**NOTICE
OSHTEMO CHARTER TOWNSHIP
ZONING BOARD OF APPEALS - REGULAR MEETING**

1. Call to Order
2. Pledge of Allegiance
3. Approval of Agenda
4. Public Comment on Non-Agenda Items
5. Approval of Minutes: August 23rd, 2022
6. **Site Plan – Faraday Defense**
Fishbeck, on behalf of Faraday Properties LLC, is requesting site plan approval for a 60,785 square foot two-story office and manufacturing/distribution facility within the Western Michigan University (WMU) Business Technology Research Park 2.
7. 2023 Meeting Dates
8. Other Updates and Business
9. Adjournment

Memorandum

TO: Oshtemo Township Zoning Board of Appeals
FROM: Kyle Mucha, AICP, Senior Planner
Paul Lippens, AICP, NCI, Vice President
SUBJECT: Faraday Defense – Office & Manufacturing/Distribution Facility – Site Plan Review
DATE: November 8, 2022

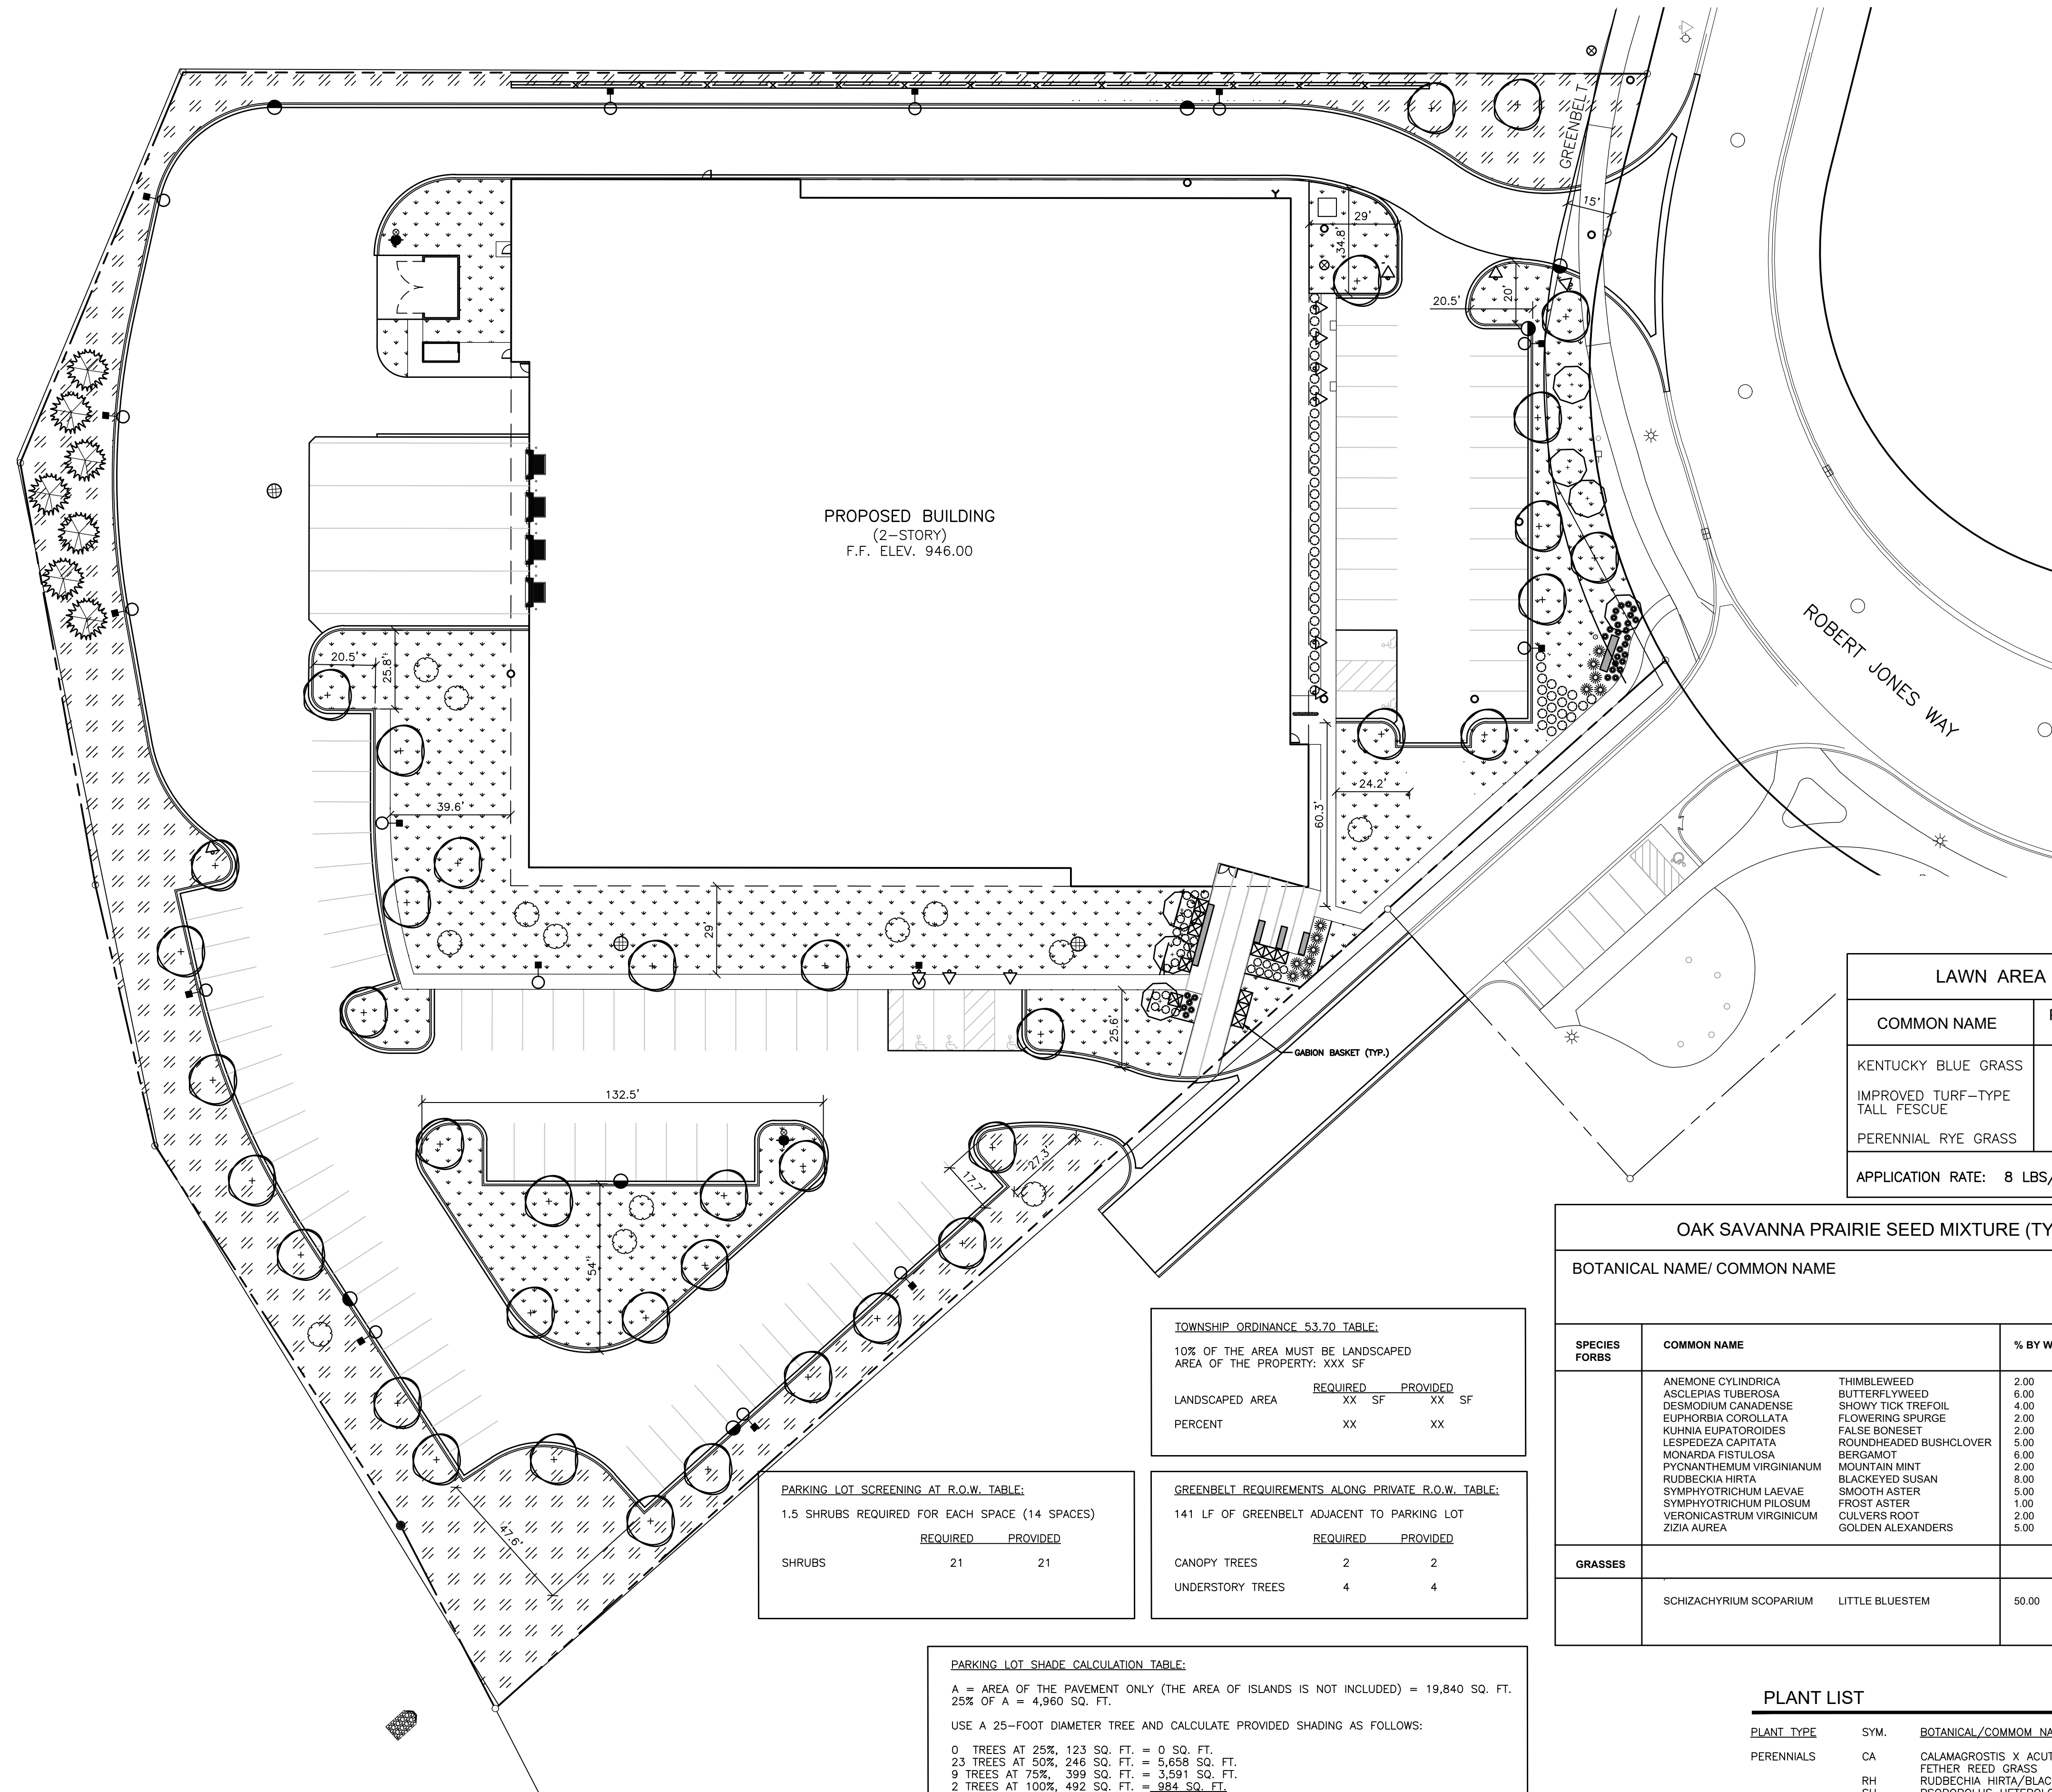
- a. Section 53.30 – Landscaping, General Provisions – requires landscaping plans to be sealed by a landscape architect for site plans that include more than 70 parking spaces. The site plan dated October 24, 2022 has not been stamped/sealed by a landscape architect.

- 2. Parking Lot Landscaping: Section 53.50.B.2 “parking lots with 11 spaces or more shall provide landscaping at 25 square feet per parking lot space”. A minimum of 2,600 square feet of parking lot landscaping is required.
 - 1. *There shall be a minimum of one (1) canopy tree and two (2) low growing shrubs for every 200 square feet of required parking lot landscaping.* The site plan depicts canopy trees within landscape islands within the parking lot. The site plan dated October 24, 2022 does not show the required shrubs and will need to be corrected.

- 3. Street Rights-of-Way Greenbelts
 - 1. *Greenbelts shall be 20 feet wide along public rights-of-way and 15 feet wide along private rights-of-way, measured from the right-of-way line.* The amended site plan notes a greenbelt of 15 feet wide which does not meet the minimum standards along Robert Jones Way. Additionally, no greenbelt is shown along the shared driveway/access road and will need to be revised to include this provision.

3. *Parking lots adjacent to street rights-of-way shall provide shrubs at a ratio of 1.5 shrubs for every one (1) parking space. Shrubs that reach a mature height of at least three (3) feet shall be utilized and they shall be in groupings spaced at least three (3) feet on center to screen the parking lot from the right-of-way.* The amended site plan provides 21 shrubs along the street right-of-way, which satisfies the requirement. However, we encourage the applicant to space out the required shrubs to better screen the parking areas from the public right-of-way.

We note that additional landscaping elements have been shown on the site plan however the calculations have not been provided as it pertains to the developed area of the parcel. Full calculations will need to be provided to confirm that the landscaping requirements have been satisfied. We advise the applicant that *“Developed area of the lot or building site shall mean the physical extension and/or construction of any man-made change or alteration to an improved or unimproved property.”* A minimum of 10 percent of the developed area of the parcel, lot or building site must be landscaped. This amount must be stated on the plan and labelled as Interior Site Landscaping Area. The area cannot include the 2,600 square feet of parking lot landscaping or the street right of way landscaping.

9. An amended landscaping plan, stamped by a licensed professional, shall be submitted to and approved by the Township prior to building permit issuance meeting the ordinance requirements outlined in this memo.

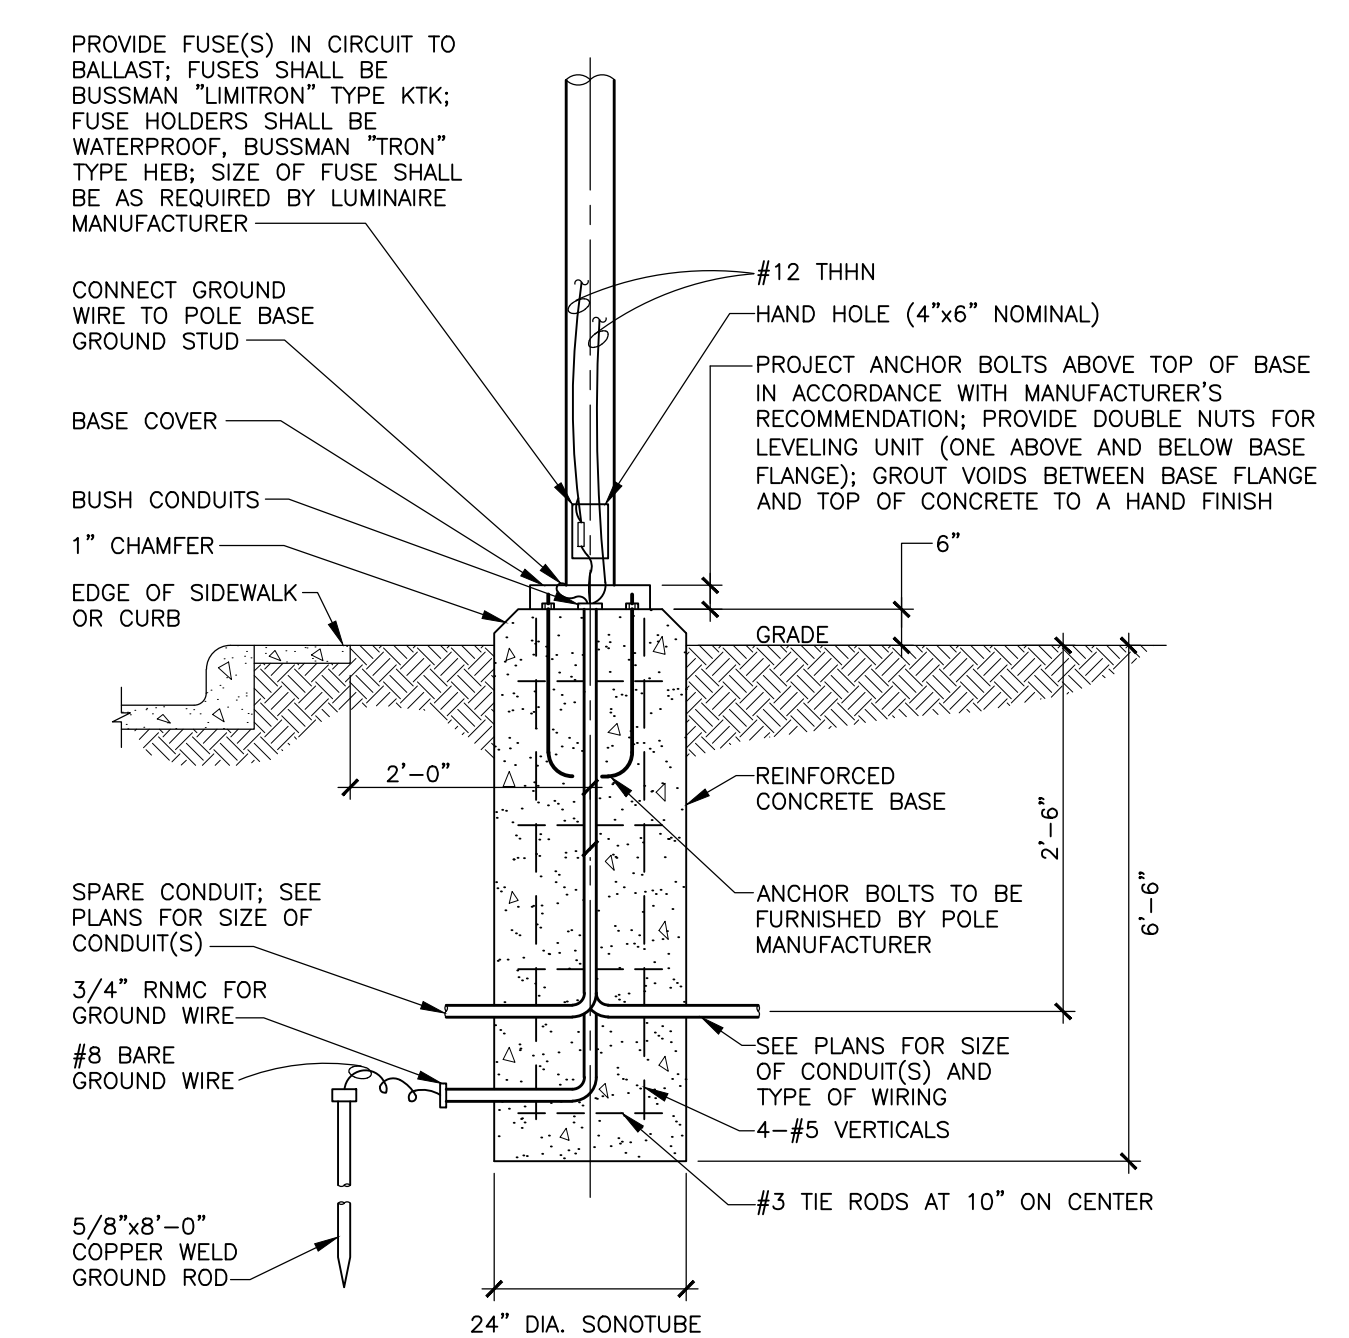
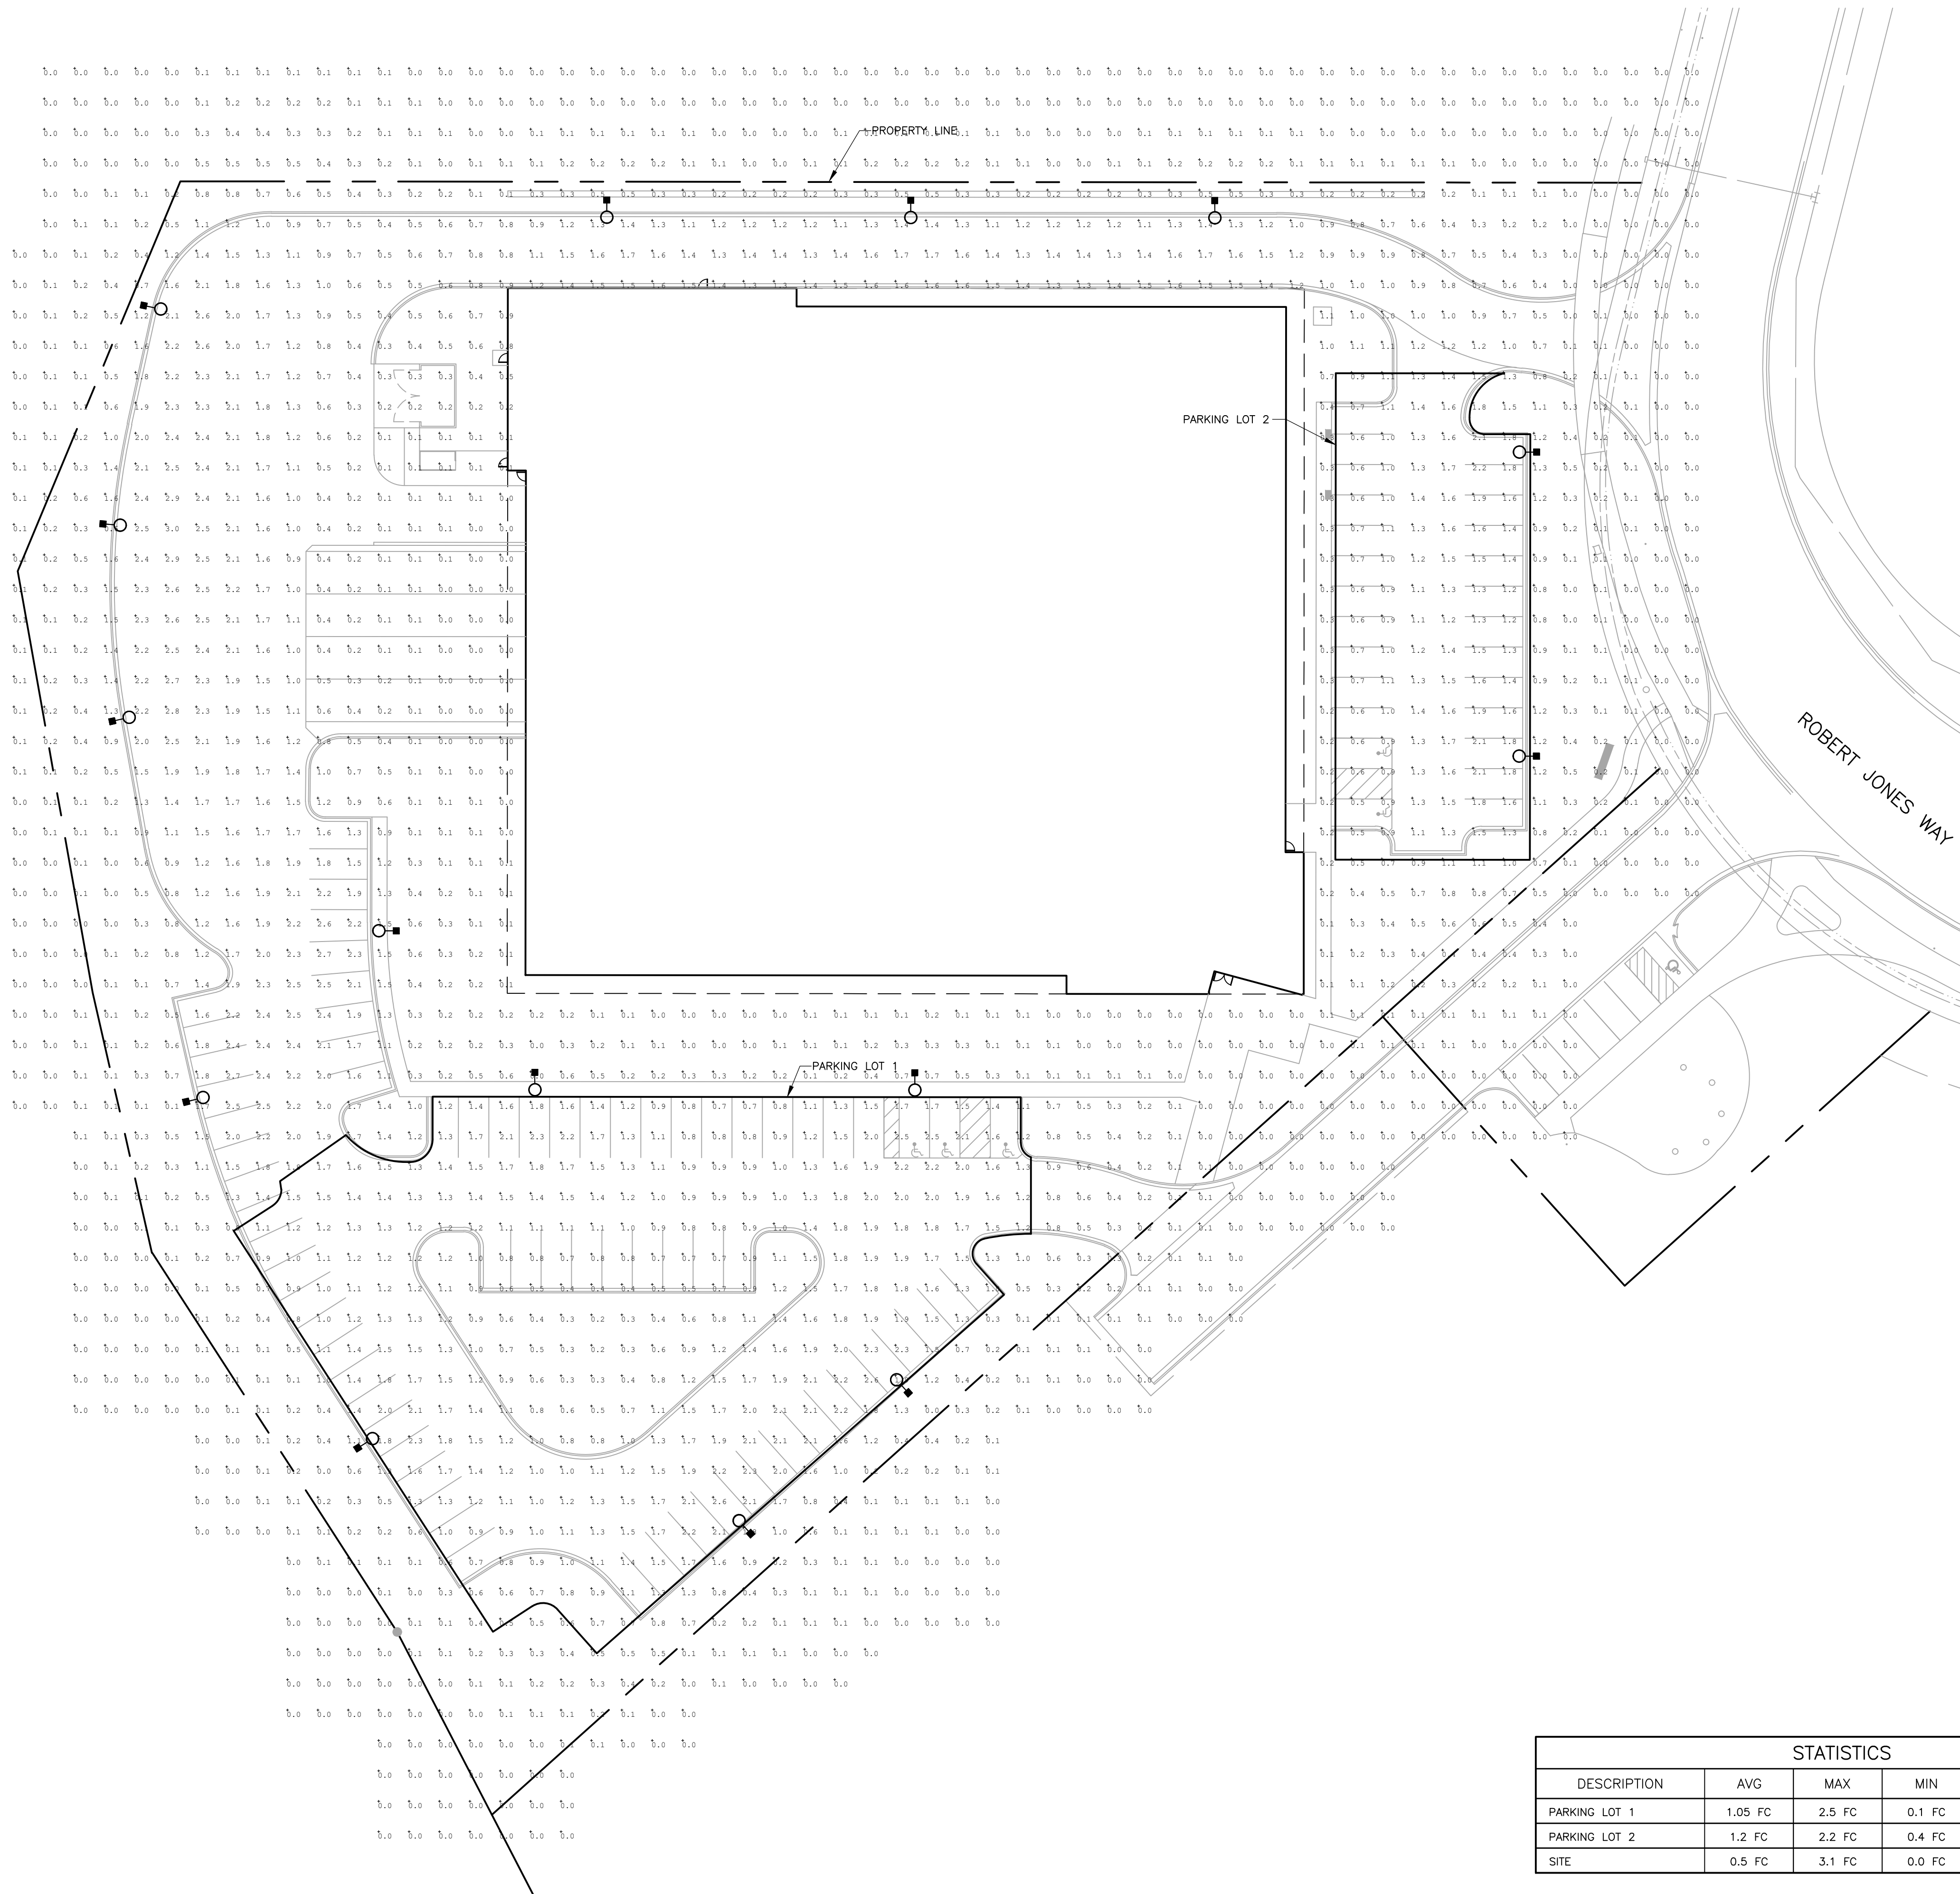
5. Landscaping Plan. The applicant has submitted a landscaping plan, which will be reviewed in a subsequent section of this memorandum.
6. Lighting Plan. The applicant has submitted a lighting plan, which utilizes LEDs as stipulated in the BRP Site Design Requirements. The proposed lighting will utilize cut-off fixtures, which will not permit light to pass beyond the horizontal plane. Further, per the submitted lighting plan, lighting is being designed to direct light onto the development and away from other adjacent property. The proposed lighting is within the color parameters as outlined within the Ordinance (Kelvin rating between 3,000 and 5,000). Per the lighting plan, and in accordance with Section 54.60 of the Township Zoning Ordinance, Outdoor Lighting Standards, the measured foot-candles of the proposed lighting will not exceed 0.5 foot-candles at the property line. The applicant will need to confirm the proposed lighting pole height meets ordinance requirements prior to issuance of a building permit.

6. Provide the height of proposed lighting poles on the lighting detail sheet prior to issuance of a building permit.
7. Install sustainable products as indicated in the applicant's response memo:
